DESCRIPTION: HYD DISC HYDRASTAR 2X102" WIDE 7480GVWR TORSION 5" TNG 76.25		PART #: 400-036246	
EFFECTIVE DATE: 10-05-20		ECN: 1166

AXLE TANDDEM
EZ-LOADER
EQUIPMENT TRAILERS
PROPRIETARY AND
CONFIDENTIAL INFORMATION

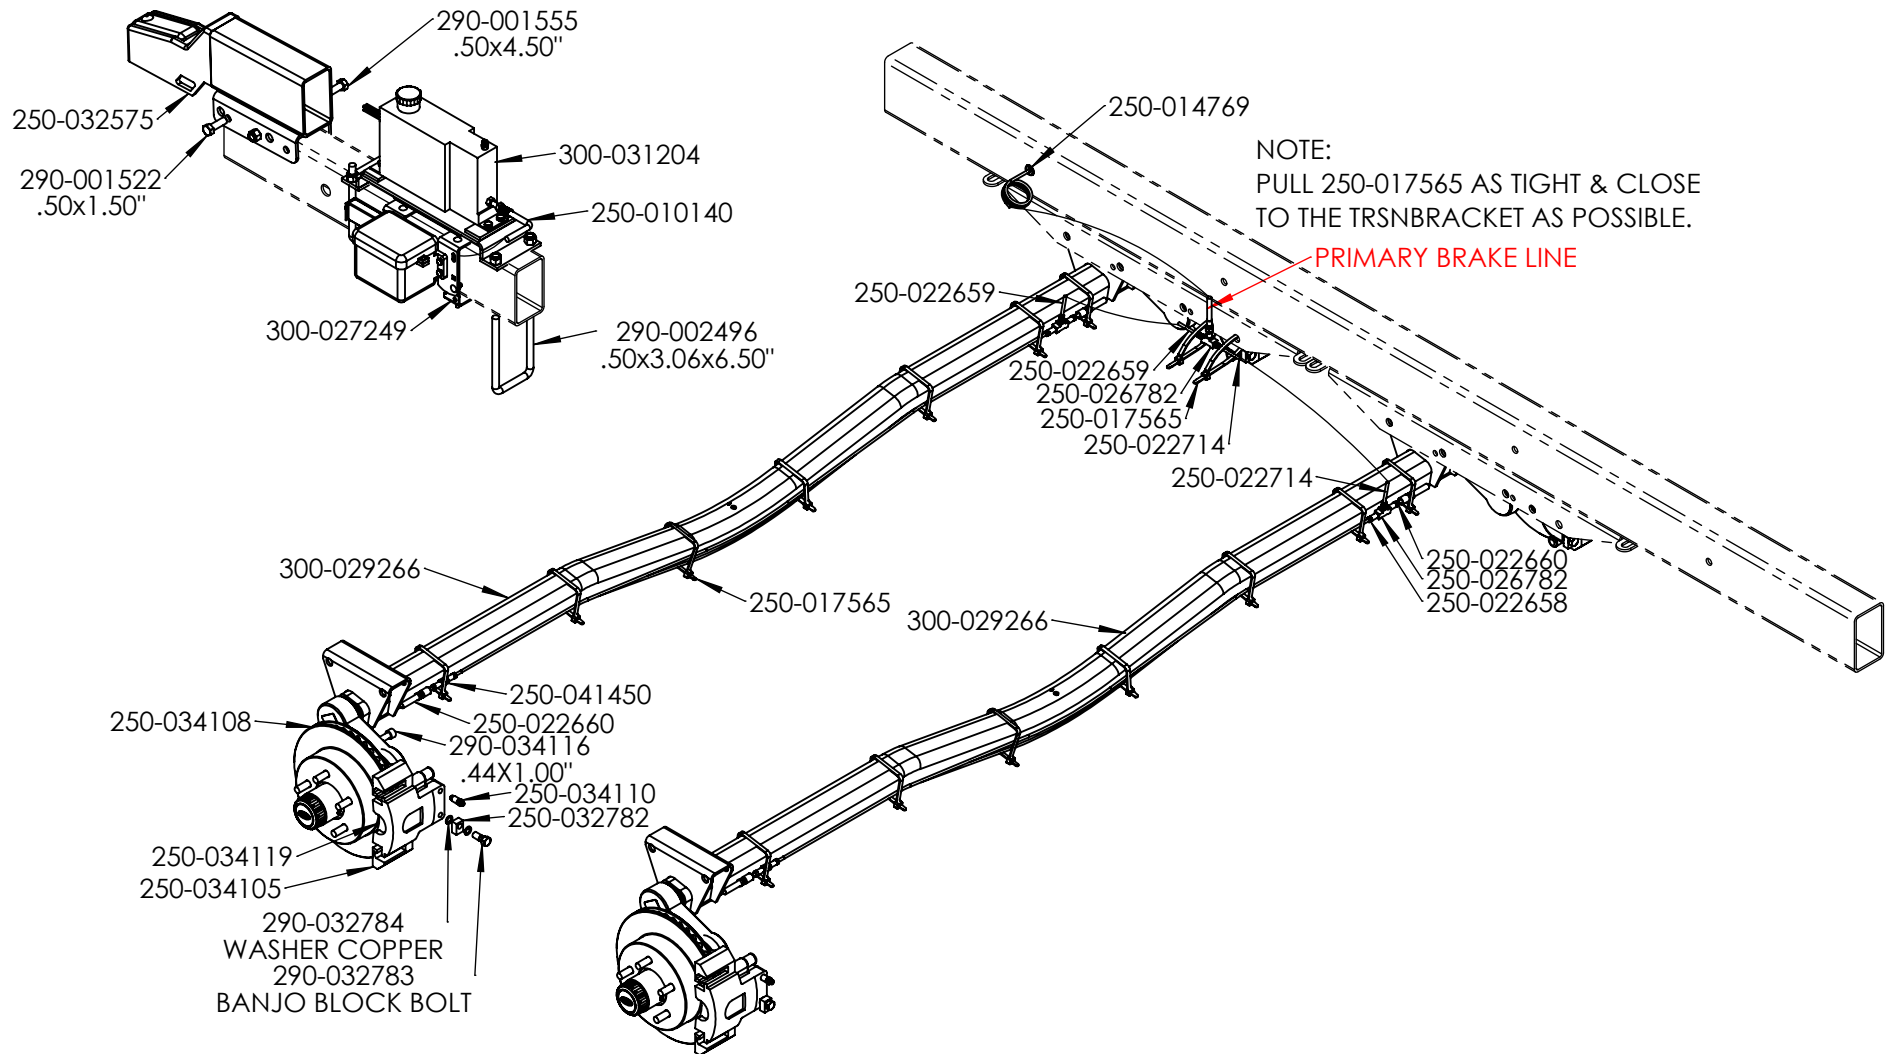
~RUN HYD HOSE BEHIND THE BATTERY BOX AND UNDER
HYDRASTAR ACTU MTG PLATE

~APPLY 250-033537 COPPER GASKETS TO ALL FLARED FITTINGS
~SEE UFP DISC BRAKE INFO PAGE

★ INDICATES CHANGE ON EFFECTIVE DATE
